CITY OF GLENDALE, CA

ADMINISTRATIVE DESIGN REVIEW STAFF REPORT – MULTI-FAMILY

1037 Ruberta Avenue

PDR2115117

WINDOW SECTION

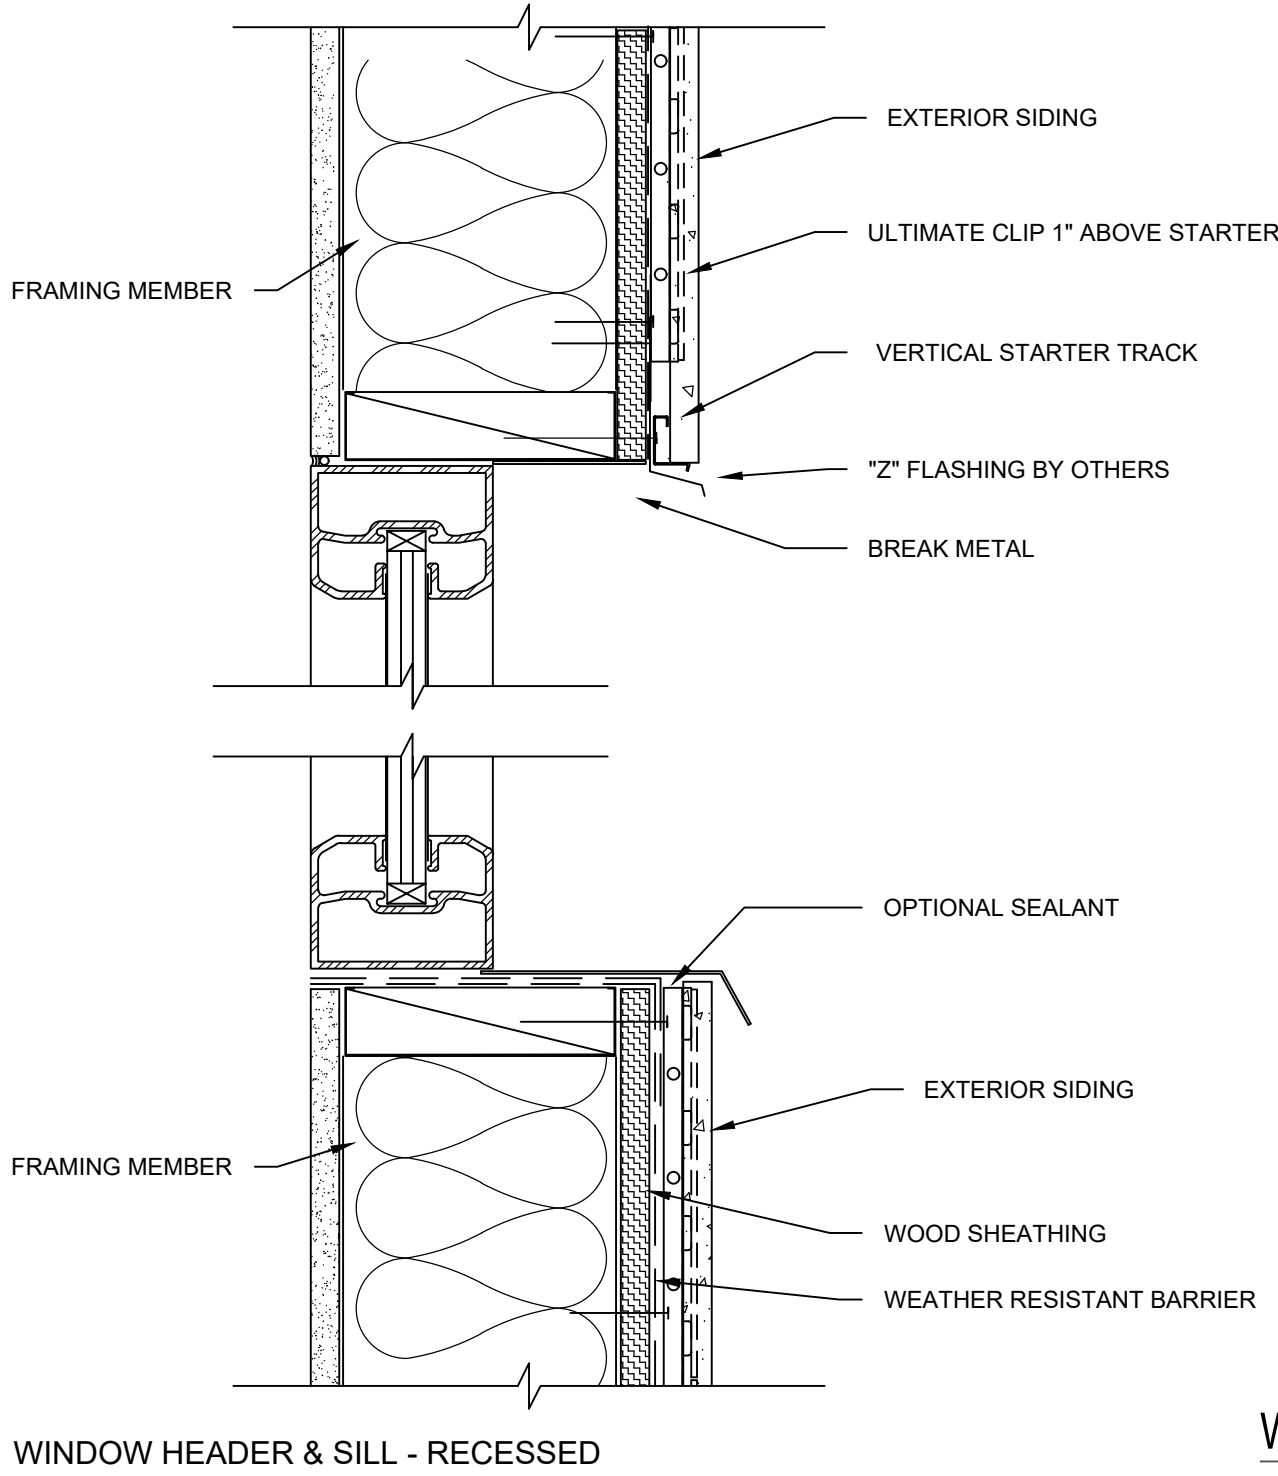
- ☐ Appropriate to overall design
- ☒ Overall window pattern appropriate to style
- ☐ Window operation appropriate to style
- ☐ Recessed/flush window appropriate to style and/or location
- ☒ Openings are well detailed

The new windows will have black fiberglass frames with combination of casement, fixed, sliding, and single hung operations with external grids. The windows are complementary to the style of the new dwellings and will be recessed with new sills and trim. Overall, the proposed windows on the building are appropriate for the design of the new units. However, a condition is added requiring that the provided vertical window section detail be revised to clearly show the new sills and trim, as shown on elevations and renderings. In addition, the proposed window grid pattern is inconsistent, showing vertical, horizontal, and square patterns. A condition is included requiring the applicant to restudy the window sizes for more consistency and to provide revised drawings for staff review and approval prior to submittal.

1. Clarify that the posts/gate are located behind building façade of Unit A.
2. Revise vertical window section detail to show sills and trim.
3. Restudy window grid patterns and provide revised drawings for staff review prior to submittal.
4. Provide information and details for: proposed railings, gate, driveway gate, posts, light fixtures on the material board or provide call-outs for all exterior material on elevations.
5. Exterior cladding material to wrap at interior corners of Unit A on north and east elevations.
